FINAL PLAT OF
"POULTER MEADOWS"
 WICHITA, SEDGWICK COUNTY, KANSAS

Re: S/D 97-102 - One-Step Final Plat of POULTER MEADOWS ADDITION

STAFF REPORT
(One-Step Final Plat-Approved 01/22/98)

CASE NUMBER: S/D 97-102 - POULTER MEADOWS ADDITION

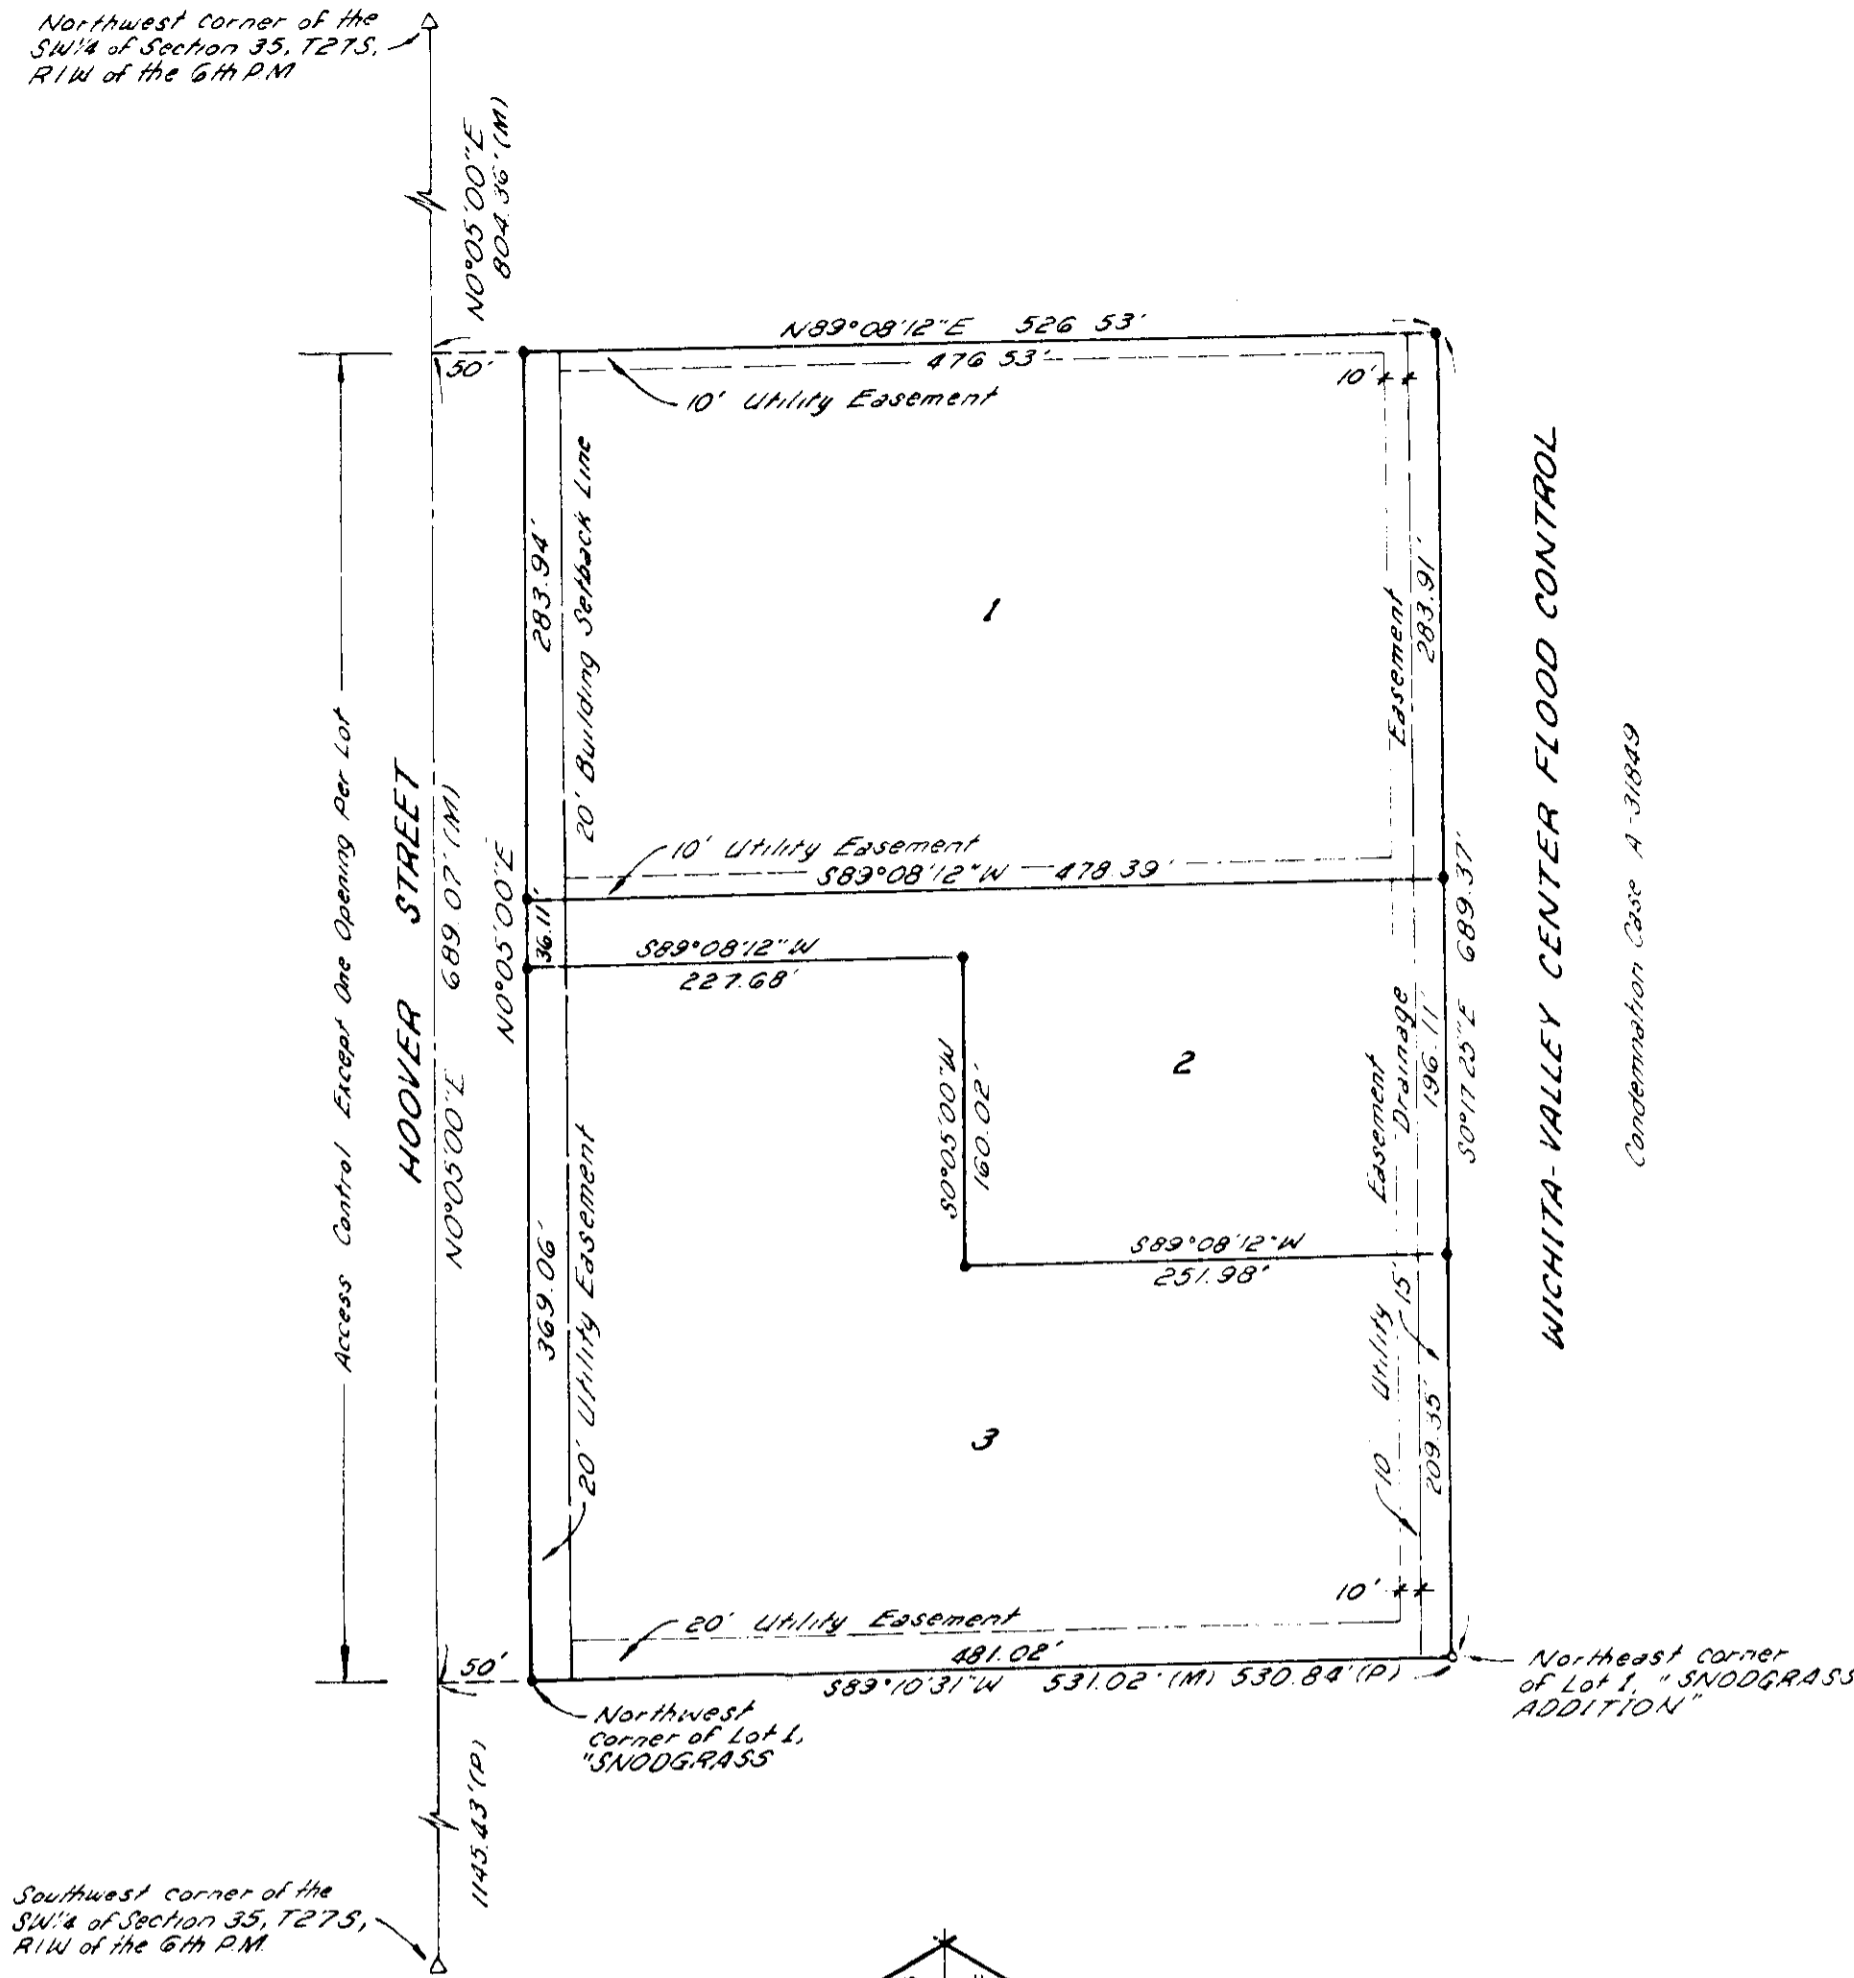
- A. **City Engineering** needs to indicate if guarantees are required for municipal services. **A guarantee for the extension of sanitary sewer is required.**

- C. **City Engineering** needs to comment on the status of the applicant's drainage plan. **The drainage plan is approved.**
- D. **Traffic Engineering** needs to comment on the need, if any, for improvements to Hoover. **There is no need for improvements.**

- E. MAPD Staff recommends that the flag lot - Lot 2 - should be eliminated and combined with Lot 1. In addition, the site should be limited to no more than two access points. **The Subdivision Committee approved the plat with the flag lot in addition to three openings; one for each lot.**

- F. The Subdivision regulations encourage shared access points for multiple lot commercial/industrial subdivisions along section line roads. **Traffic Engineering** needs to comment on the need for access controls along Hoover. **Traffic**

Engineering recommends one opening for each lot.

- H. The MAPC Chairman should be revised to read Richard Lopez.
- I. The signature line for Pat Burnett should read "City Clerk".
- J. If the current lot configuration is approved, the final plat tracing should show a 20-foot building setback in conformance with the LI zoning requirement. The setback line for Lot 2 should be measured from the 160-foot interior north-south lot line.

- K. Based upon the legal description shown on the plat, the site involves the 50-foot strip along the west line of the plat and would in effect be a dedication of street right-of-way for Hoover Street. Both the face of the plat and the platator's text should show and reference such dedication.

- M. The applicant is advised that accessory structures such as the indicated shed on Lot 1 would not be allowed without a principal structure also being located on the same building site. Approval of this plat with the current lot configuration would be conditioned upon the removal of this shed.

- T. The representatives from the utility companies should be prepared to comment on the need for any additional utility easements to be platted on this property. **KGE has requested additional easements.**
